## GOVERNMENT HILL COMMUNITY COUNCIL

**Subject: Government Hill's remarks regarding FEIS comment responses.**

Government Hill respectfully submits the following remarks in response to selected published comments and responses in Appendix K of the FEIS.

KABATA's 2007 Annual Report prominently displays the picture below:

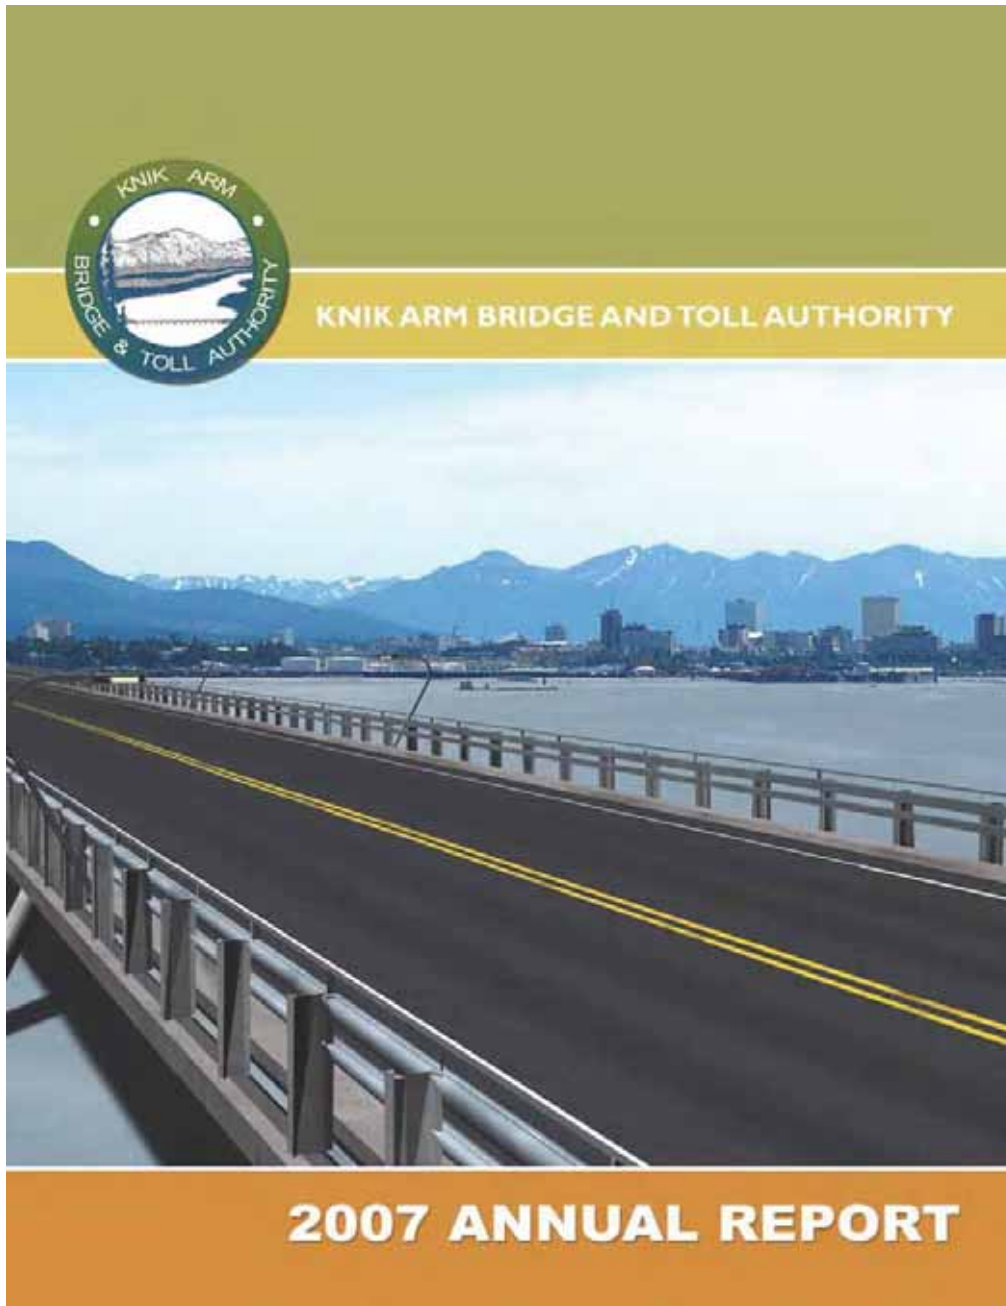
The bridge is depicted as two lanes lacking any sort of pullout. The Knik River bridge on the Glen Highway also was originally a two lane bridge. It experienced major problems with ice fog due to the open water and cold temperatures. It was also the site of many accidents until the second bridge was built, special lights installed, and turned into a fully divided 4 lane highway, which has lessened the number of crashes. If the Knik Arm Crossing is built as a two lane bridge, one can only imagine the results of a multi-car crash in the middle of the bridge due to ice fog and zero visibility on a 1.5 mile long bridge over open water in freezing conditions. It will take hours, if not days, to clear out the wreckage. That is not an "effective" road.
